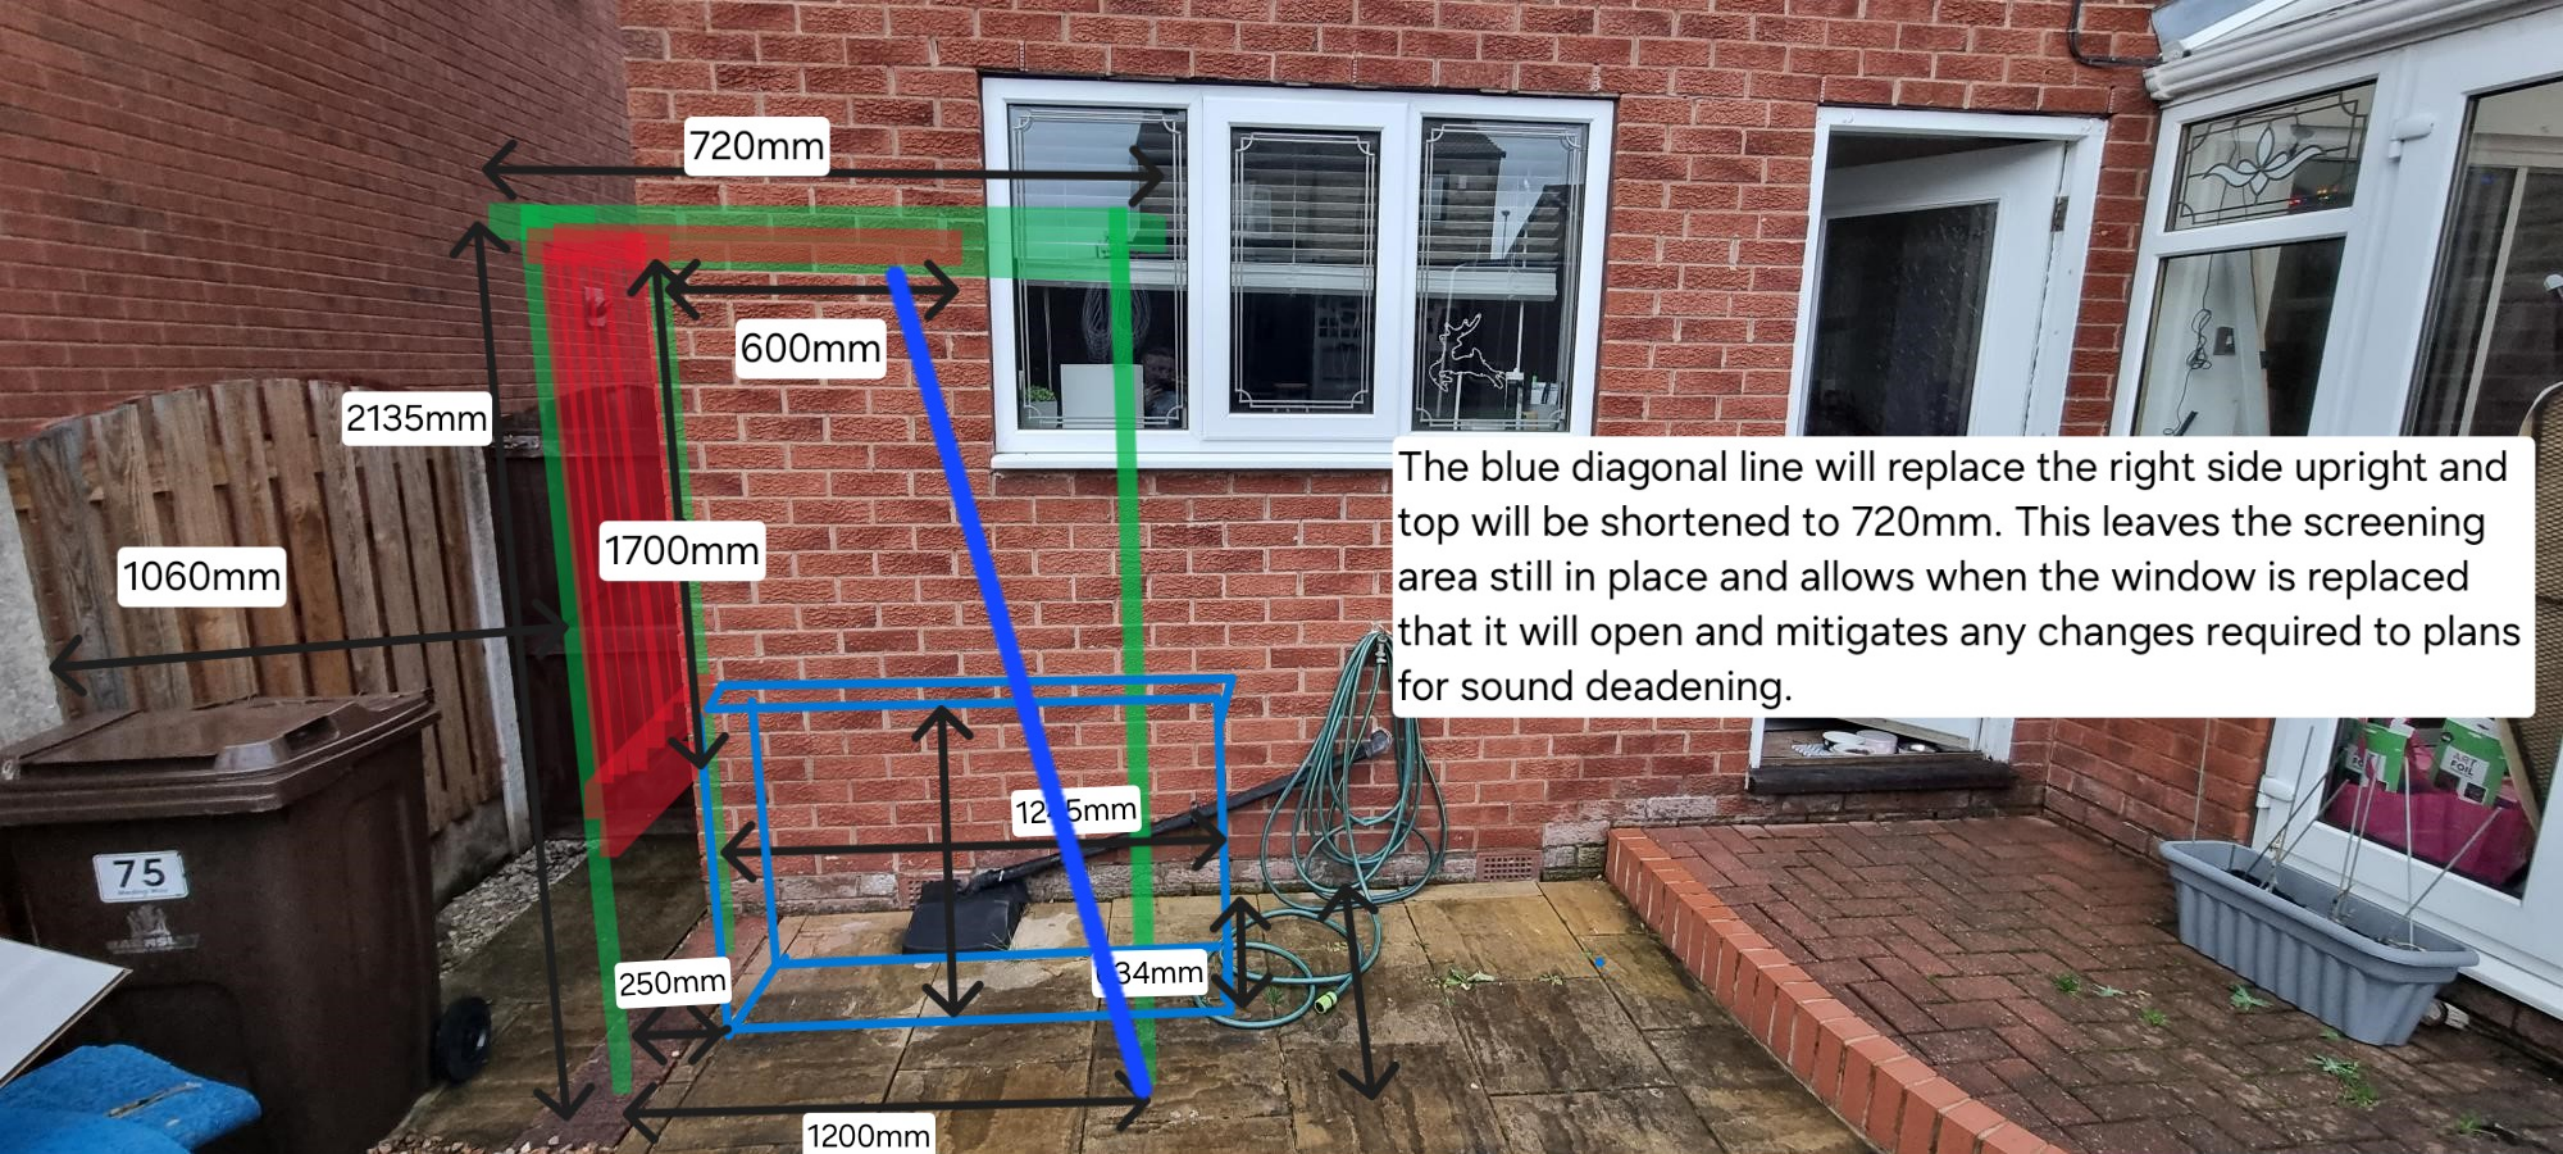
The blue diagonal line will replace the right side upright and top will be shortened to 720mm. This leaves the screening area still in place and allows when the window is replaced that it will open and mitigates any changes required to plans for sound deadening.
